Vapor Intrusion Assessment 825 Stewart Drive, Sunnyvale

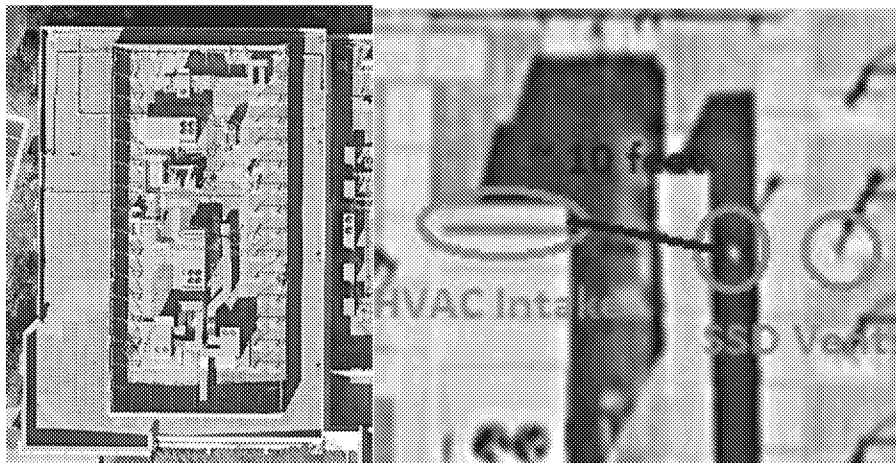
Passive subslab depressurization systems (SSDs) were installed on the three connected buildings at 825 Stewart Drive prior to installation of a building ventilation system. It appears that the mechanical design of the HVAC system applied the standard 10-foot distance between building exhaust vents and HVAC intakes to the SSD exhaust for the west and main buildings. The HVAC system upgrades also included features that limited air flow from the SSD vents on these buildings. It is recommended that these impacts to the SSD operations be mitigated.
